58. The groundwater flow direction was noted to be generally SW from WCGS to the Neosho River. Are there any localized groundwater flow directions to Wolf Creek (below CCL)?

Subject: Docket No. 50-482: 2005 Annual Environmental Operating Report

Figure 3 Pole 20 of the 13.8 kV distribution power loop where center phase conductor insulation is recommended to prevent potential bald eagle electrocution. Note close horizontal cross-arm configuration.

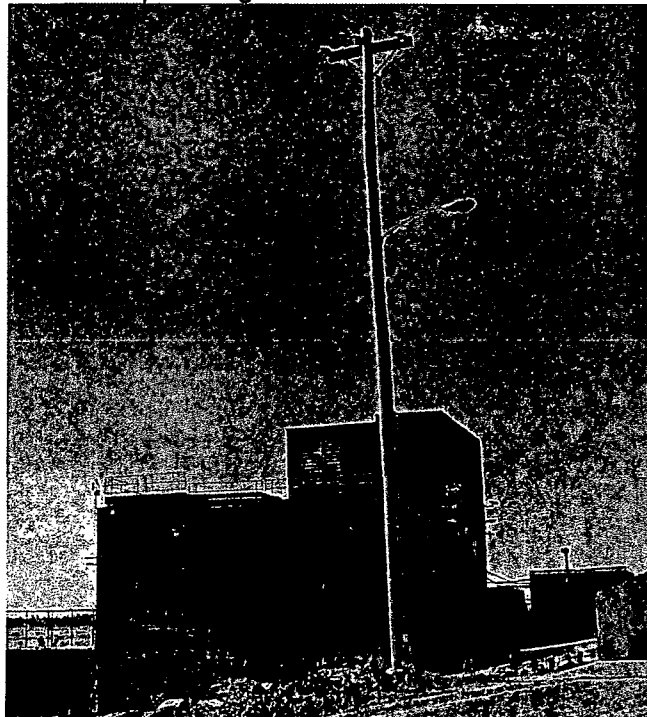
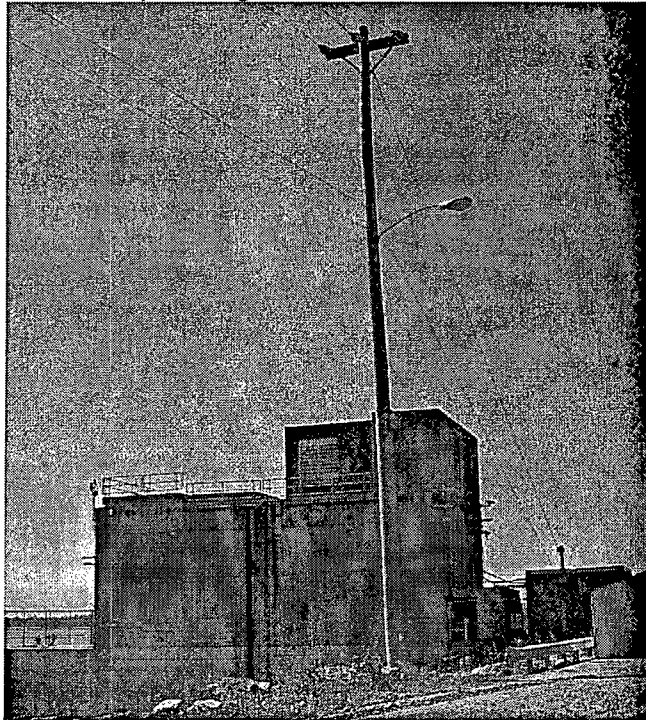
Of the likely roost poles identified in Table 1, only pole 20 was considered potentially dangerous to bald eagles (Figure 3). This pole has close conductors and a horizontal cross-arm configuration. The pole is also adjacent to water habitats, and may be an attractive roost site, especially for wintering bald eagles foraging around the lake. All remaining poles judged as likely roosts were not considered hazardous to bald eagles due to the multiple factors beneficial for preventing eagle electrocution as identified in Table 1.

1. Install insulation on the center conductor on pole 20 from the bushing approximately three feet (Figure 3) to eliminate potential for bald eagle electrocution.
2. Install perch deterrents and/or insulate center conductors on poles 54 through 59 (Figure 4). These modifications will reduce electrocution potential caused by the closely spaced horizontal conductors.

Photo 1. Bald eagle perch deterrents installed on Pole 20.

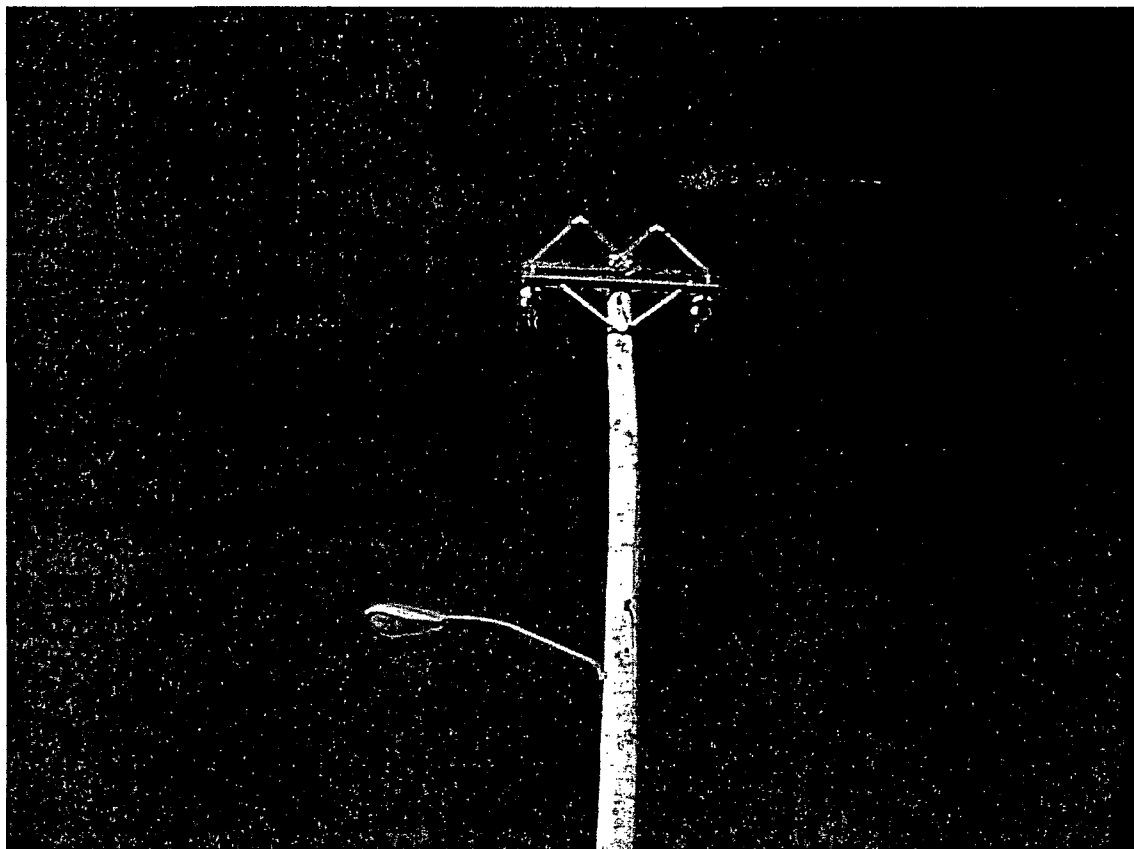
These addendum statuses the improvement items for avian protection identified in Section 5.2. The protection item changes are as follows:

Insulation of the center conductor and jumper on Pole 55 will be installed when scheduling will allow during an upcoming Construction Power Loop outage.
